PROJECT REVIEW COMMITTEE - CITY OF WILDWOOD

SUBJECT: PLATM 2404-004 Tillman Oaks Improvement Plan Modification

PROJECT: PLATM 2404-004 Tillman Oaks Improvement Plan Revision #1

LANDSCAPE PLAN

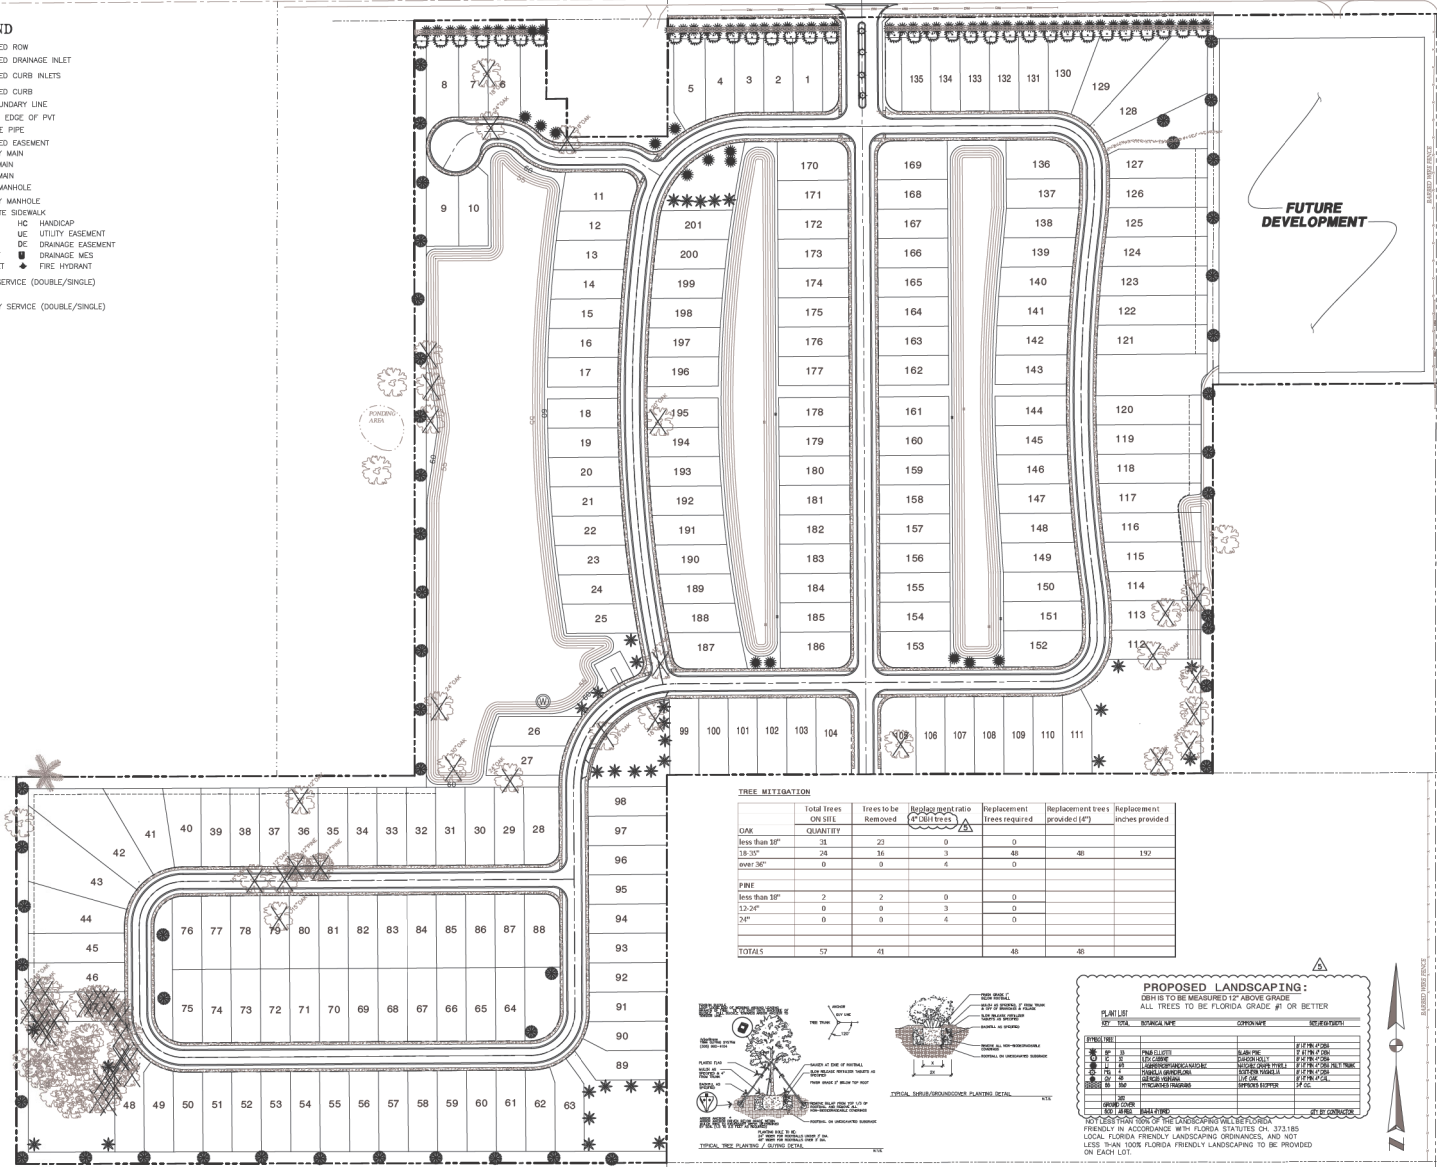
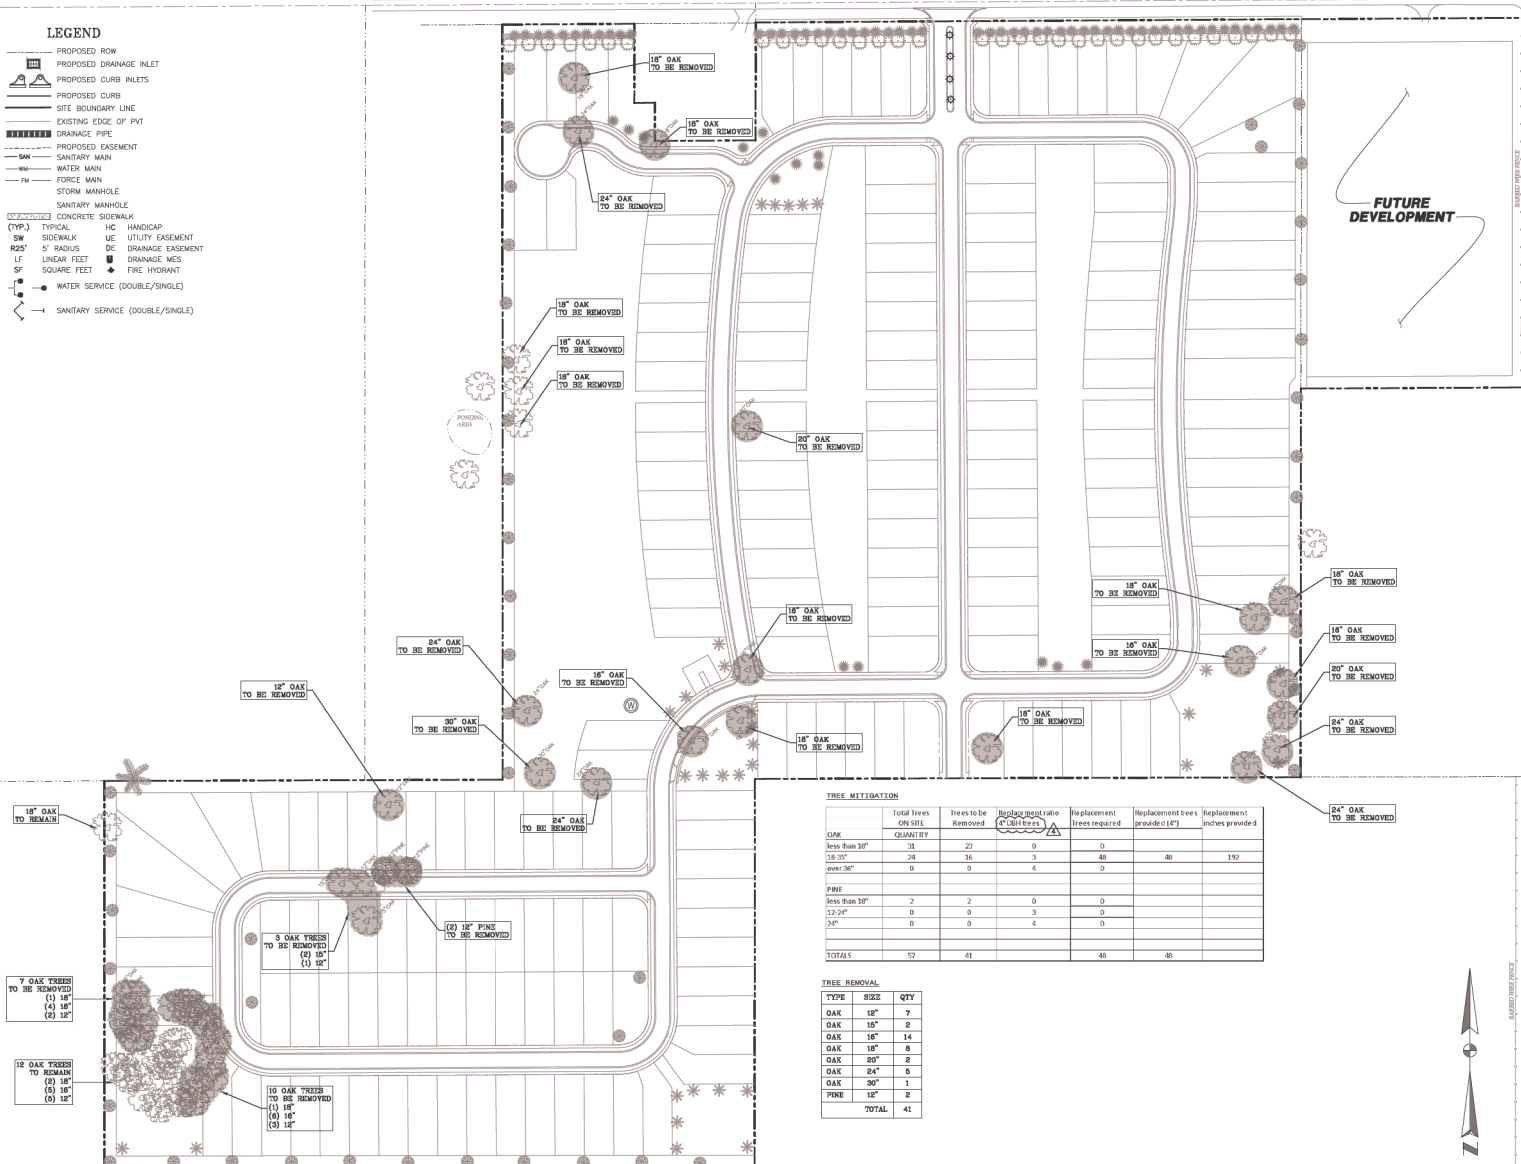
1. LDR 6.10(H). Plan Sheet L1 Plant List. Caliper is not an acceptable measurement.
